febi 39925, 102532, 104870, 104871

Strut mounting with friction bearing

Figure 1 - febi 39925: 3-hole M10

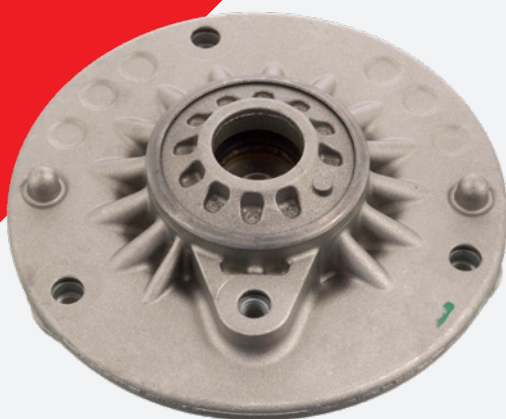
In the case of the F2x and F3x models up to model year 05/2013:

If the strut mounting with a M8 thread is fitted, the strut mountings must be replaced in pairs by using two strut mounting kits (104871) with the M10 thread. This includes all fixings, suspension- strut buffer and dust cover.

The changeover of thread M8 to M10 results in a different level of stiffness. Therefore, a mixed installation of mountings (M8/M10) is not permitted!

If the strut mountings have already been replaced once with the M10 thread mounting, the installation of an individual strut mounting is permissible.
